**P00-127 Meadowview Plaza**

**REQUEST:** Entitlements to allow the construction of three retail/commercial buildings totaling 37,964± square feet on 4.75± vacant acres in the General Commercial Review (C-2R) zone at the northeast corner of Meadowview Road and Freeport Boulevard:

P00-127  
Revised Site Plan  
Submitted 12/6/00

EXHIBIT 1d

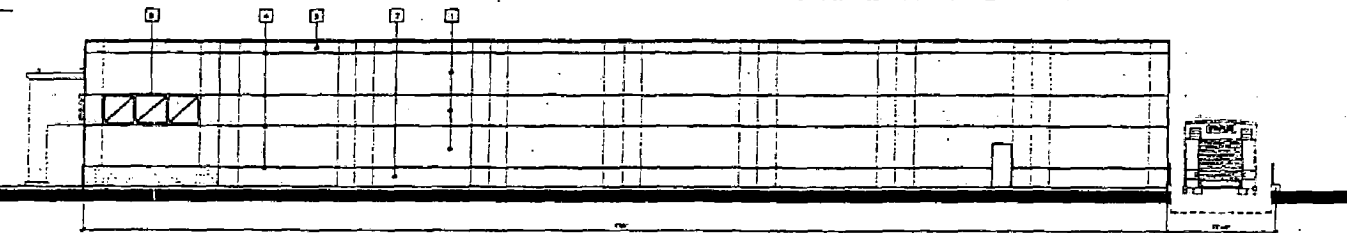
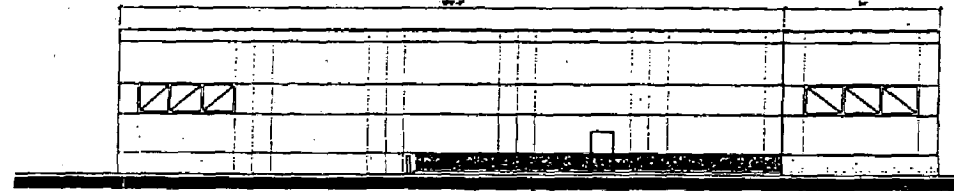
Staff is recommending that the tubular trellis's on the Staples and the 10,000 square foot retail building be modified to incorporate landscaping similar to the landscaped trellis's located adjacent to the Home Depot. As proposed the three buildings will help reduce the appearance of the large Home Depot building. In addition, the design and color of these buildings will complement the existing development.

- D12. The owner/applicant shall comply with all requirements of the Mitigation Monitoring Plan prepared for this project;
- D13. The proposed Staples development shall be constructed as shown on the attached elevations (Exhibit 1d), including the following features/accents as shown:
- a. Split-face CMU Block veneer wainscoting and pilasters;
  - b. Almond/Tan Stucco exterior walls and reveals;
  - c. Green standing seam metal roofing on the exposed metal trusses/canopies (two total) located on the south elevation;
  - d. Clear glass windows/doors at the entrance to the building;
  - e. Applied metal accents; and
  - f. Ground Mounted Up lighting along the south (Meadowview Road) elevation;

WEST (FREEPORT BLVD.) ELEVATION

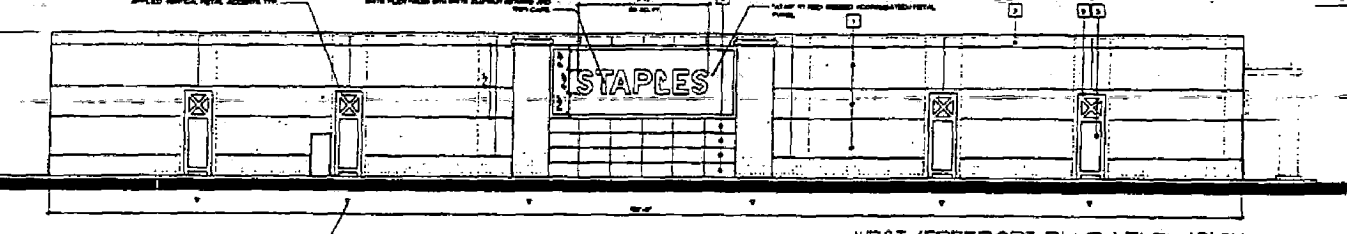
- D14. The metal accents shown on the west elevation (Ereepart Boulevard) shall be replaced with tubular Steel Trellis's (to match existing trellis structures on the Home Depot building). Landscaping/vines shall be planted at the base of each of the trellis's in order to allow landscaping to soften the building elevation;
- D15. The proposed trash enclosure shall meet the requirements of the adopted trash enclosure guidelines;
- D16. The trash enclosure shall be designed to allow walk-in access by tenants without having to open the main enclosure gates;
- D17. Trash enclosures shall be constructed of concrete block or similar masonry material and finished with stucco or other material which is comparable in color and texture to the building facades;

EXHIBIT 1e  
Building B (IHOP) Elevations

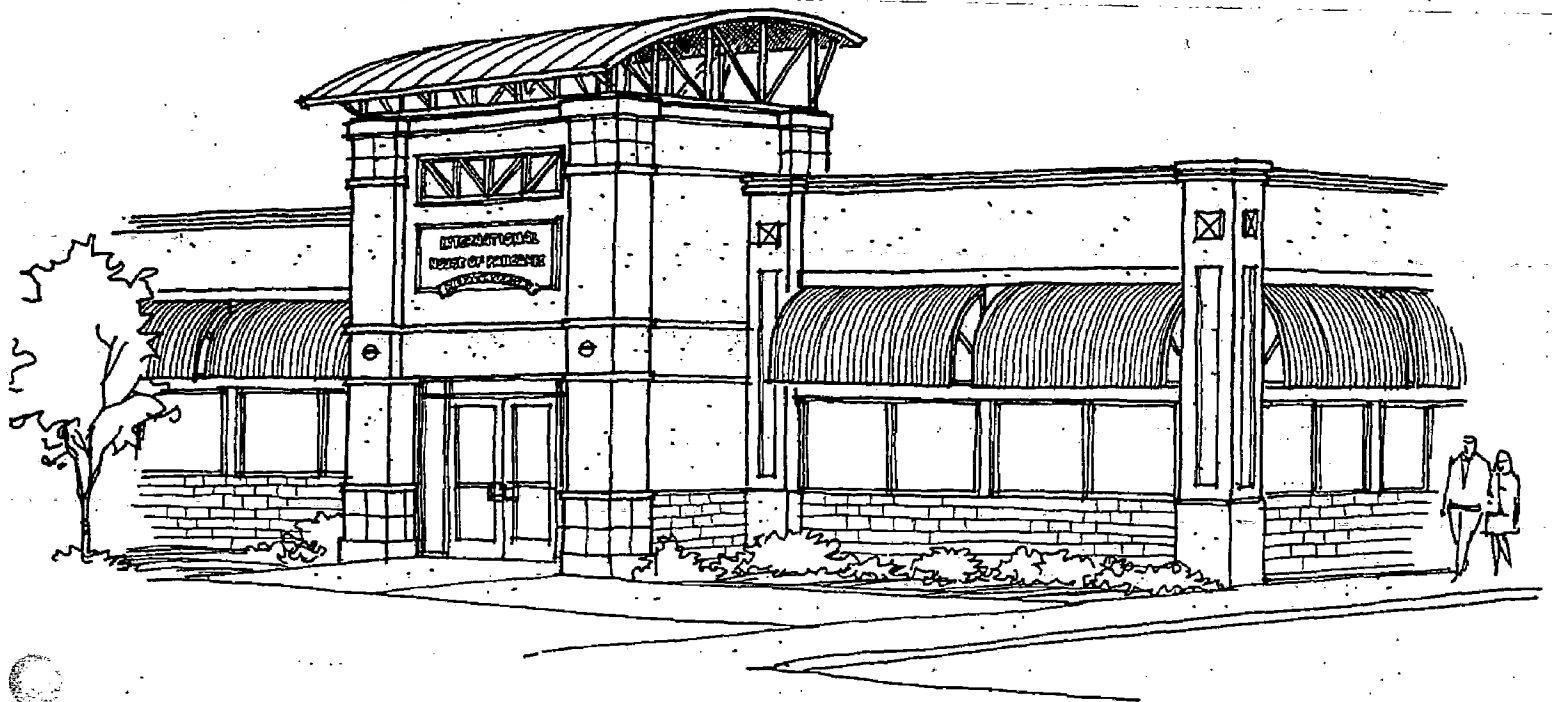
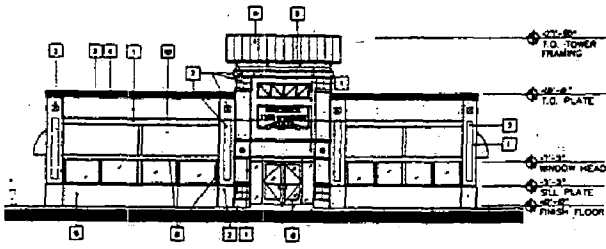
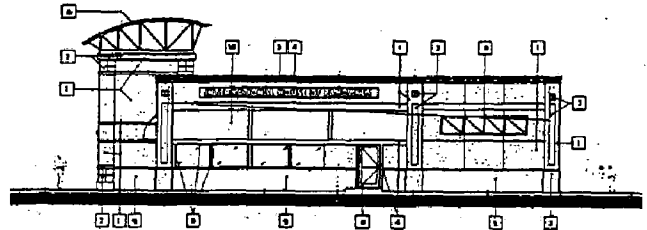
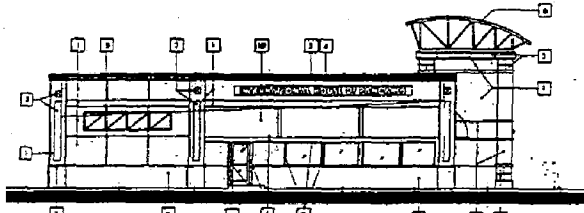
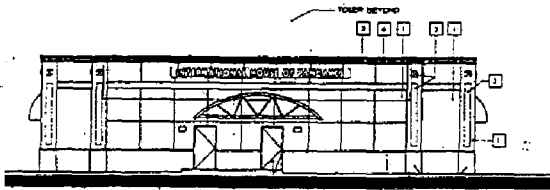
- E12. The owner/applicant shall comply with all requirements of the Mitigation Monitoring Plan prepared for this project;
- E13. The proposed IHOP development shall be constructed as shown on the attached elevations (Exhibits 1e & 1f), including the following features/accents as shown:
- a. Split-face CMU Block veneer wainscot and pilasters;
  - b. Almond/Tan Stucco exterior walls and reveals;
  - c. Green standing seam metal roofing on the tower element;
  - d. Open steel trusses on the front (south) elevation;
  - e. Blue Corrugated metal canopies over the windows;
  - f. Clear glass windows/doors at the entrance to the building;
  - g. Applied metal accents and exposed trusses; and
  - h. Blue Gooseneck Light Fixtures to be located above the canopies towards the top of the building.

**EXHIBIT 1g**  
**Building C Elevations**

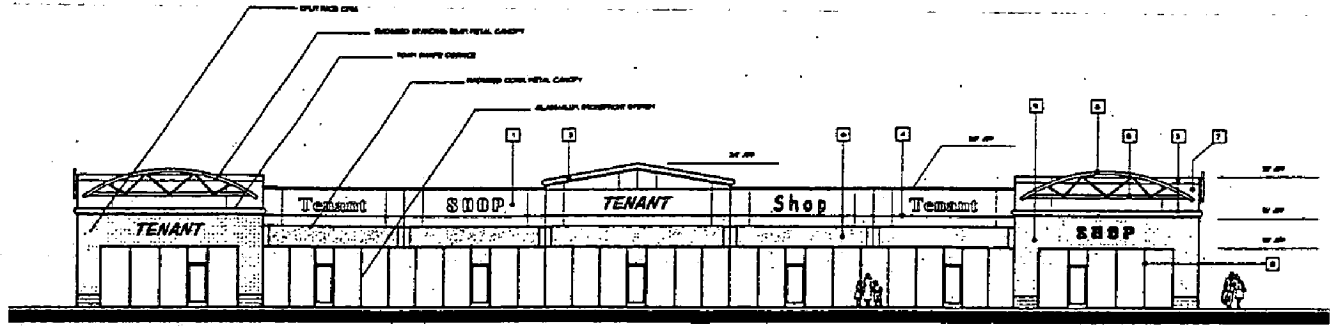
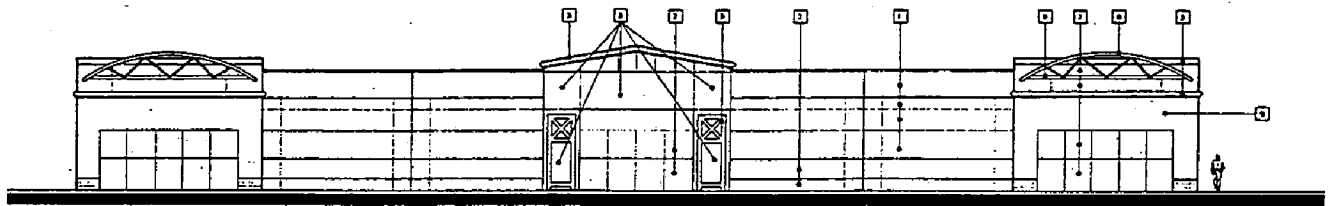
- F12. The owner/applicant shall comply with all requirements of the Mitigation Monitoring Plan prepared for this project;
- F13. The proposed 10,000 square foot retail/commercial development shall be constructed as shown on the attached elevations (Exhibit 1g), including the following features/accents as shown:
- a. Split-face CMU Block veneer and pilasters;
  - b. Almond/Tan Stucco exterior walls and reveals;
  - c. Green standing seam metal roofing on the exposed metal trusses/canopies (six total) located on the four elevations;
  - d. Green Corrugated metal canopies over the windows;
  - e. Clear glass windows/doors at the entrance to the building;

- F14. The metal accents shown on the south elevation (Meadowview Road) shall be replaced with tubular Steel Trellis's. Landscaping/vines shall be planted at the base of each of the trellis's in order to allow landscaping to soften the building elevation;
